HISTORIC AND DESIGN REVIEW COMMISSION

Agenda Item No: 28

HDRC CASE NO: 2016-339
ADDRESS: 324 W MULBERRY AVE
LEGAL DESCRIPTION: NCB 3001 BLK 3 LOT 5
ZONING: R5 H
CITY COUNCIL DIST.: 1
DISTRICT: Monte Vista Historic District
APPLICANT: Gilbert Gonzales/Dynamic Contracting Services
OWNER: Donna Romo
TYPE OF WORK: Hardscape
REQUEST:

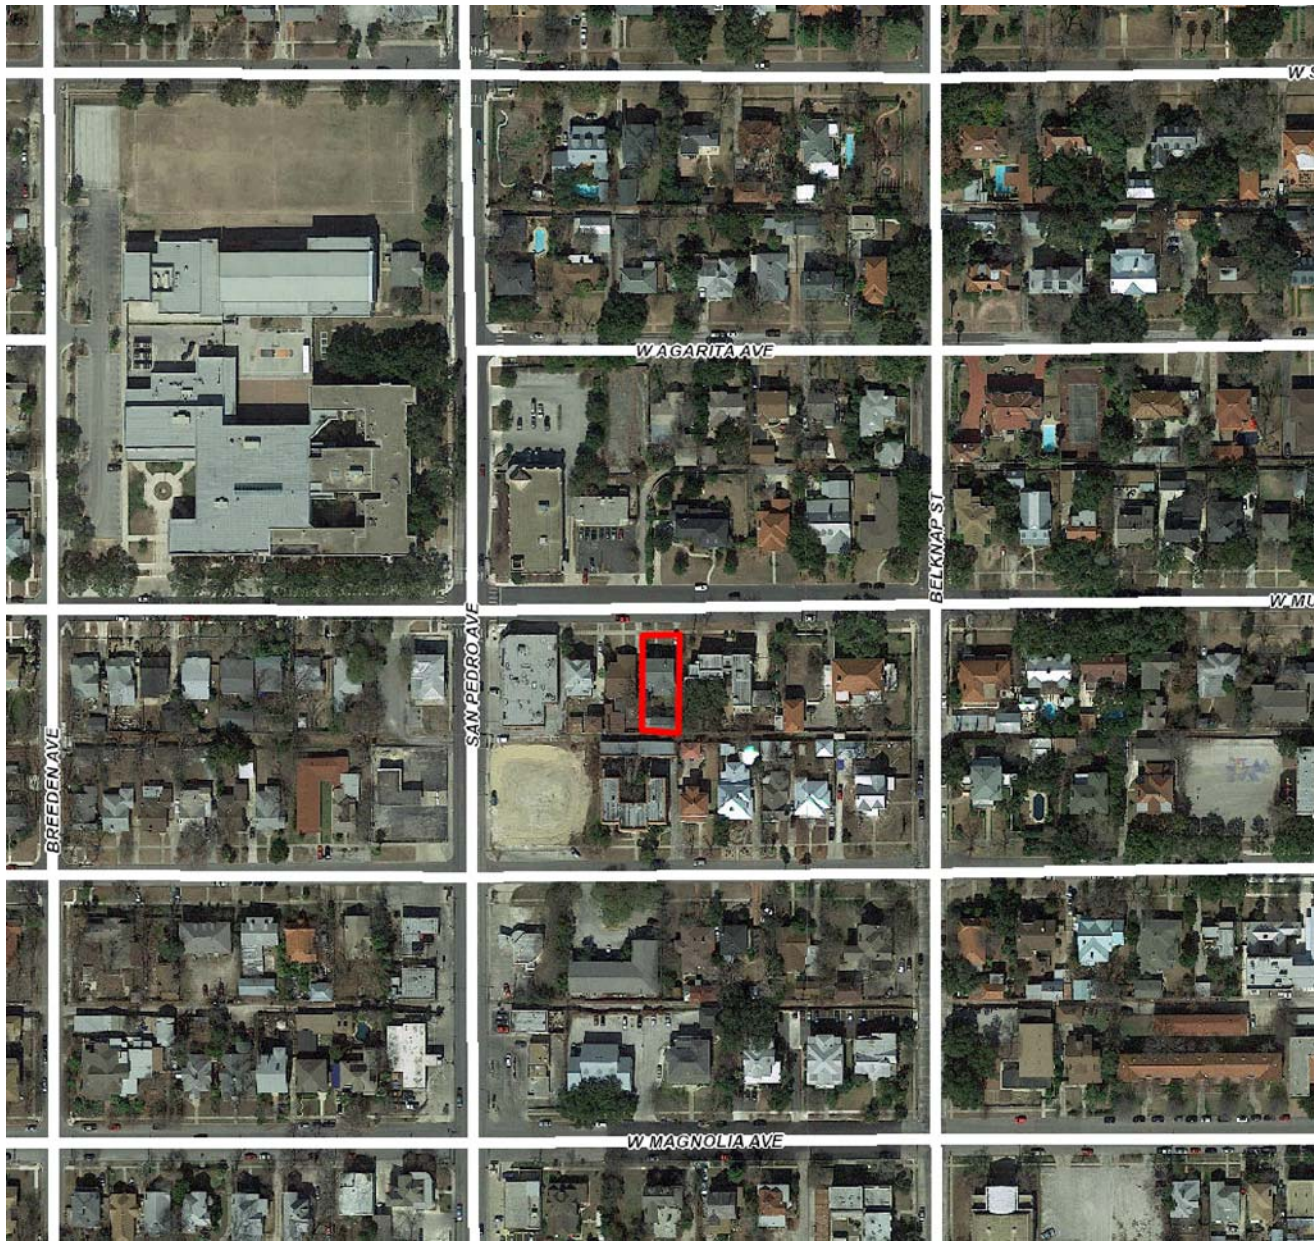
- a. The home located at 324 W Mulberry Ave is a two-story craftsman style home in Monte Vista Historic District, designated in 1975.
- b. The applicant received administrative approval to remove the existing non-original tile on the front steps, refinish the concrete on the front steps with a clear grit finish, and to replace existing concrete sidewalks and walkways with the same material, color, and configuration and with a salt finish.
- c. There is a concrete flat finish sidewalk existing. The proposed new front walkway is made of stamped concrete in the same location as existing front walkway configuration. The proposed walkway will be stained with a darker tan color. According to the Guidelines for Site Elements 5.A.i, sidewalks should be replaced to match existing color and material. Staff finds the proposal not consistent with the Guidelines.

Staff does not recommend approval based on finding c.
